Pacific Grove Unified School District
435 Hillcrest Avenue, Pacific Grove, CA 93950
Robert Down Elementary School Site Improvements
Notice to Bidders - Addendum 03

Addendum Date: 3/23/2026

AD03-01: Revisions to Project Manual

AD03-02: Pre-Bid Questions and Answers

SHEET #
E201

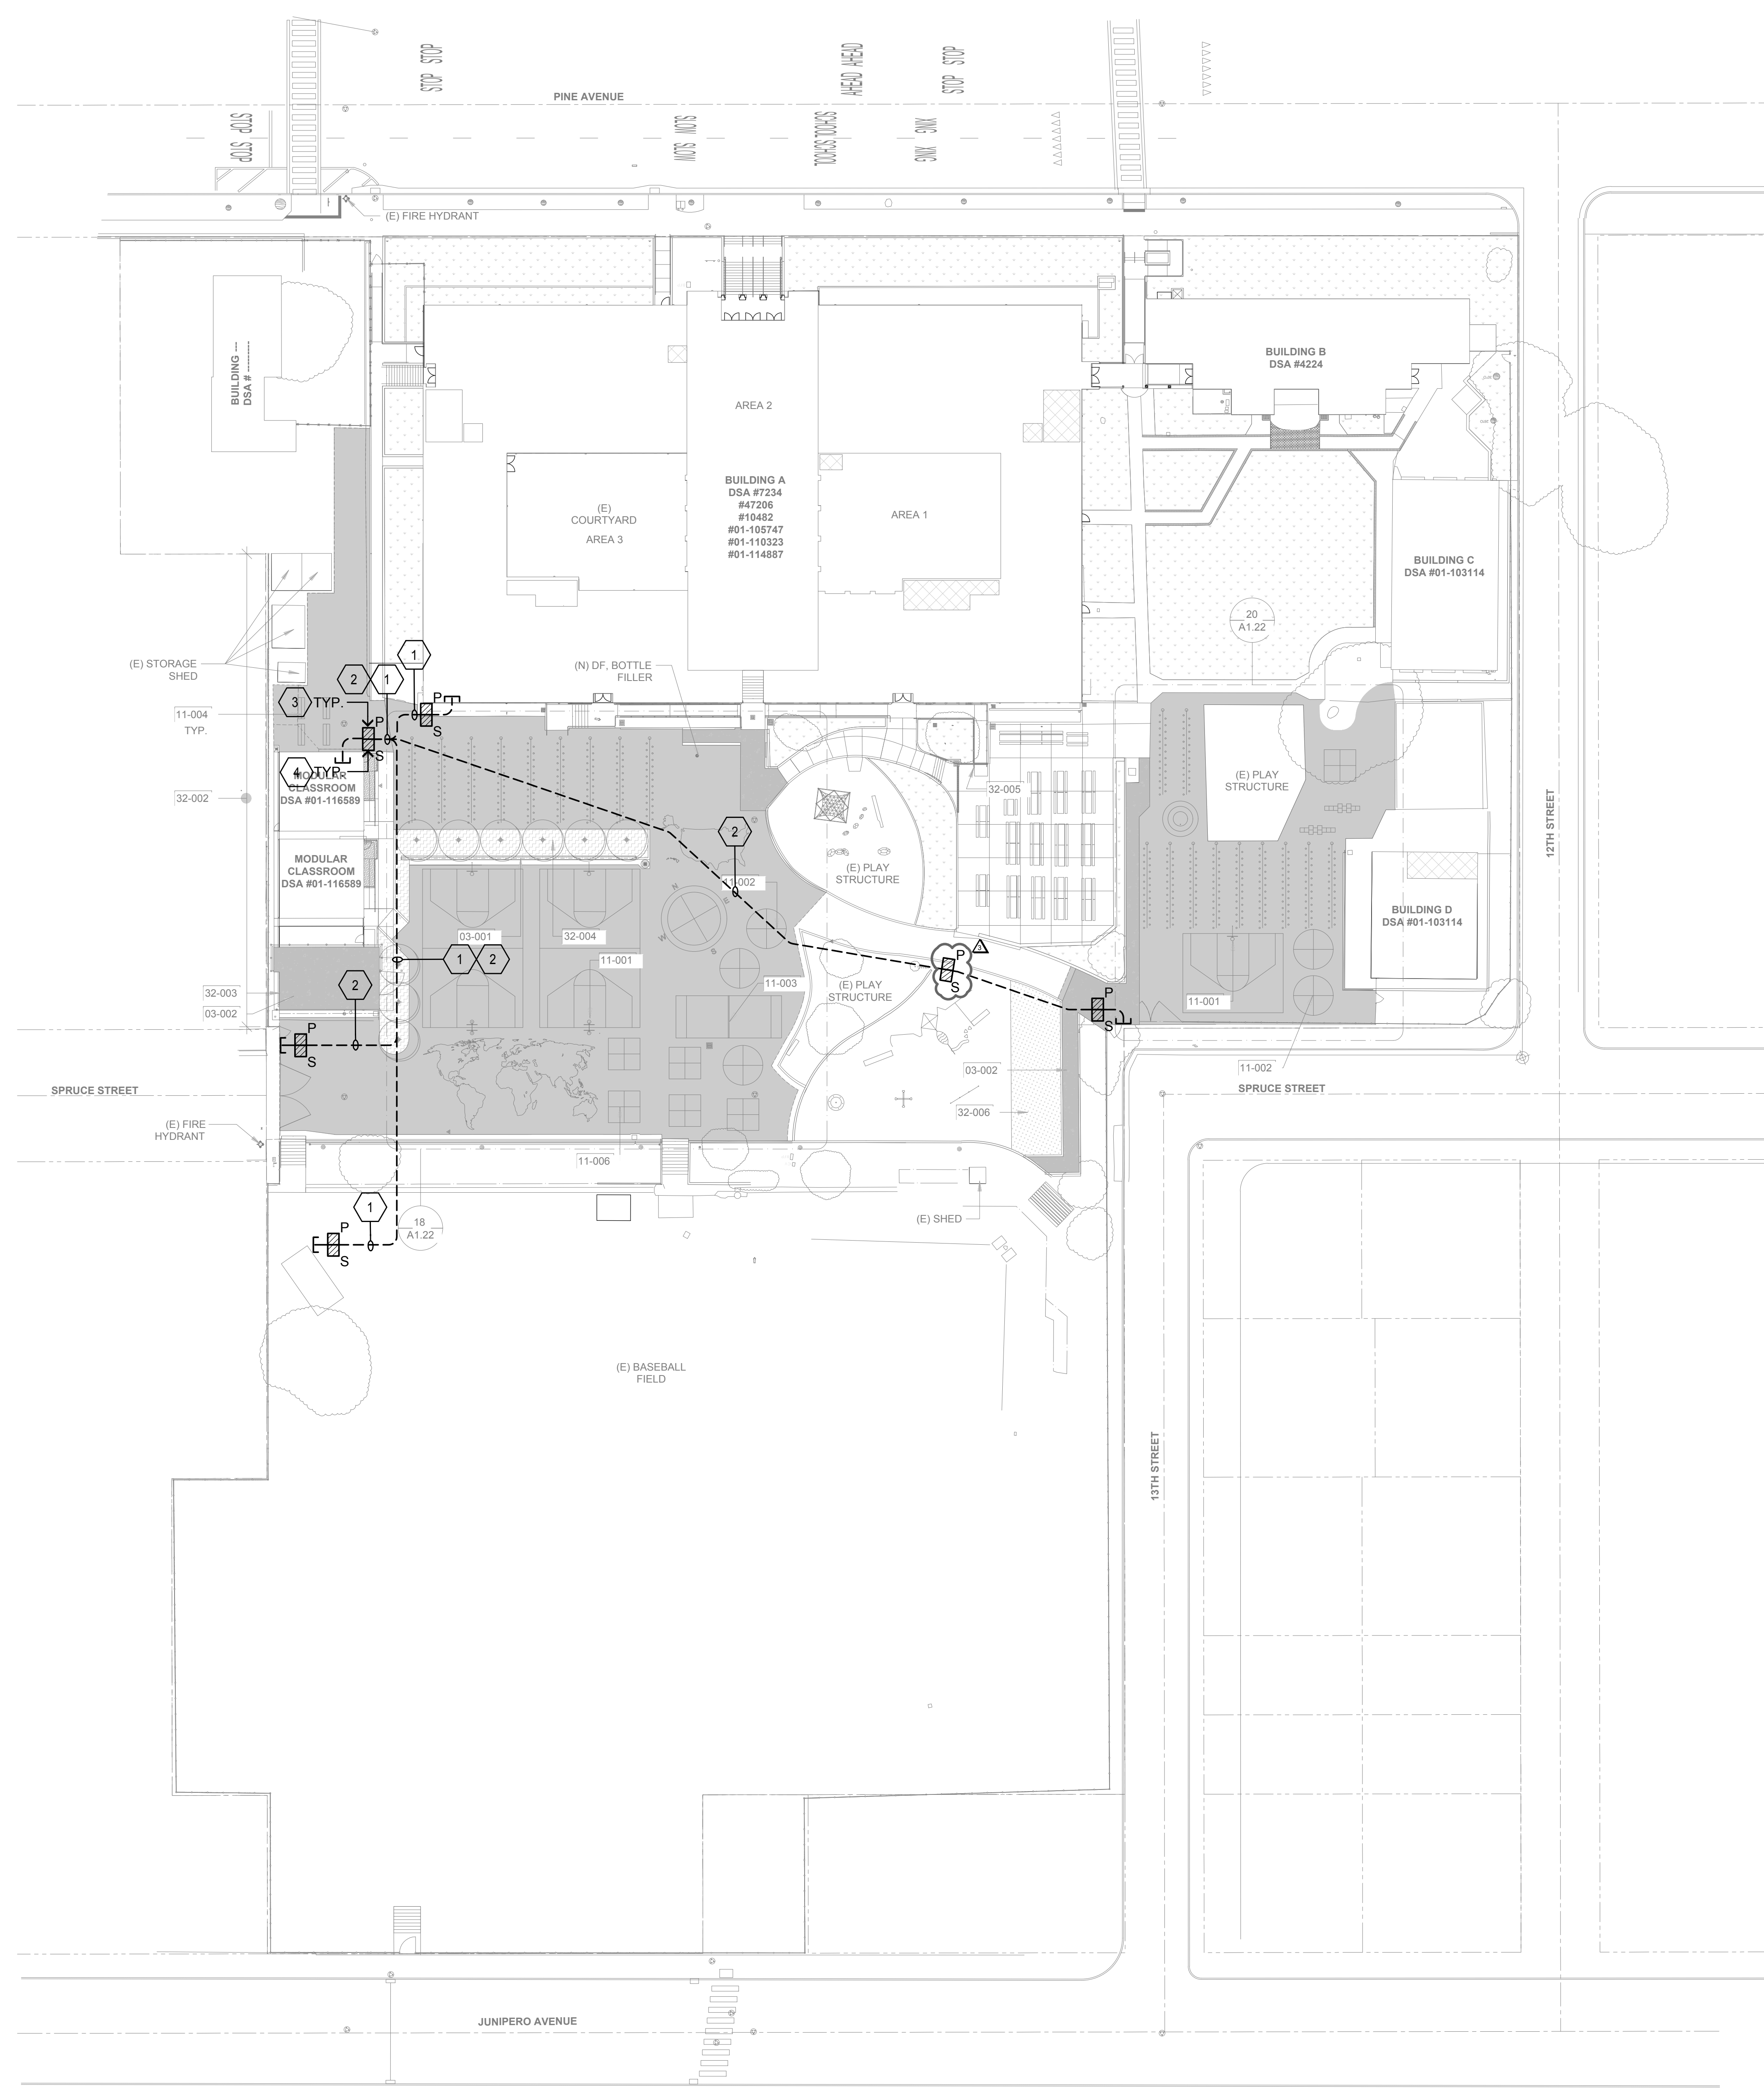
ITEM 3D.019 E201 - ELECTRICAL SITE PLAN
Add: Add pull- box per E201 - ELECTRICAL SITE PLAN.
